ID #	Bidder's Question	Gemini's Answer
01	Can we change the structure of the Contractors list during Phase B, for instance, to integrate new competencies?	It is possible for the Contractor to add or remove subcontractors during Phase B. Gemini would expect advance notification and justification to any major changes once the Phase B contract had been awarded to assess the impact on cost, schedule, requirements and risk and to demonstrate the change would be in the best interest of the project. Final authorization would be granted by an amendment from the AURA Contracts Officer.
02	RTC: Can we have an idea of the degree of freedom to change or adapt the RTC proposed?	Gemini has subcontracted the design and build of the Real Time Controller. It is being built to the specification contained within "GNAO-RTC-RFP-002 - RTC Specifications Requirements v4.0". If possible, proposers should submit bids compliant with the provided RTC specifications. However, alternative provisions may be proposed for Gemini to consider. It should be noted that any proposed changes to the RTC specification would require acceptance by the RTC subcontractor.

Figure 1. Ref for question ID#11.

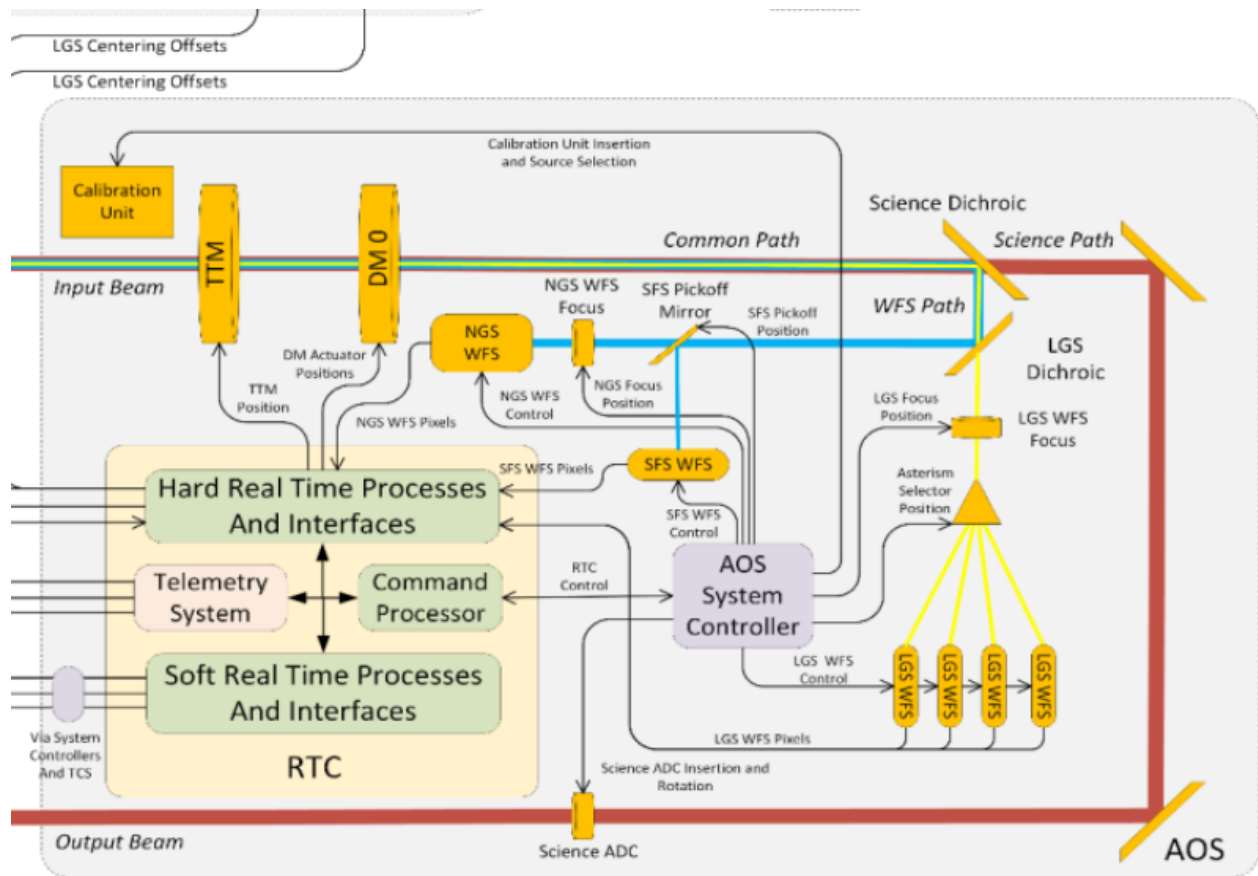
(https://auracas.aura-astronomy.org/procurement/aura-bid-opportunities/)
10	<p>Is it possible to get the presentations and results (e.g., minutes or Q&A) from the meeting? Do you also have a list of meeting attendees?</p>	<p>Yes, the recording of the Zoom meeting is posted on the AURA Bid page (https://auracas.aura-astronomy.org/procurement/aura-bid-opportunities/) under the “Zoom Meeting” section (bottom of the entries for “Documents” of RFB #N00006593C).</p>
11	<p>We noticed that the Real Time Controller was put out to bid in 2019 (https://www.gemini.edu/news/request-proposal-gemini-north-adaptive-optics-real-time-controller). If the RTC part of the GNAO Bench is out of scope, is the AOS System Controller (see Figure 1. Ref for question ID#11 presented below this table) also out of scope of the project?</p> <p>In other words, is the scope of the project only the GOLD elements in the figure below, or does it also include the software and electronics to control them?</p>	<p>Yes, the AOB System Controller will be provided by Gemini, it is outside the scope of the AOB contract. The AOB vendor is responsible for delivering control electronics for each device (including DMs and WFSs) that will allow the device to be controlled via an ethernet interface and linux device drivers. All control software above this device control layer will be the responsibility of Gemini.</p> <p>It is envisioned that most devices will be controlled using commercial off-the-shelf (COTS) components (i.e. commercial motor controllers). If a COTS controller is not available for any chosen device, the electronics and software required for ethernet control of that device will be the responsibility of the vendor.</p> <p>Note that the GOLD elements and optical path shown in the diagram are for illustration only, they are not intended to influence the AOB design.</p>
